INNER WEST

DEVELOPMENT ASSESSMENT PANEL REPORT

Application No.	REV/2024/0014
Address	2/215 Lilyfield Road LILYFIELD NSW 2040
Proposal	Section 8.2 Review of DA/2023/0565 determined on 13/02/2024, for alterations and additions to an existing single bedroom apartment unit including new stairs to upper level bedroom on new second floor, roof modifications, and other associated works, review involves amended plans.
Date of Lodgement	19 June 2024
Applicant	David Springett
Owner	Ms Jennifer M Madz Mr Warren M Briggs Logan Creative Pty Ltd
Number of Submissions	Initial: 0
Cost of works	\$103,400.00
Reason for determination at Planning Panel	DA previously refused by the IWLPP
Main Issues	Streetscape
Recommendation	Approval with Conditions
Attachment A	Recommended conditions of consent
Attachment B	Plans of proposed development
Attachment C	Report for DA/2023/0565
Attachment D	Minutes of panel meeting - 13 February 2024

1 DA18
 East Elevation-Adjoining 213 Lilyfield Road
 Scale: 1:100 @0.3

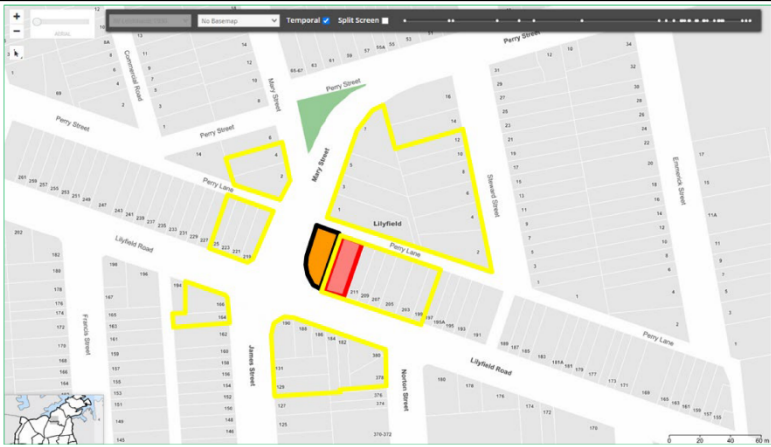
Modified: Sloping boundary wall and roof
 Who retreats to: Internal face of existing boundary wall

- Original lodged boundary wall
- Modified boundary wall as per recommendation
- Plan
- Profile
- Roof floor
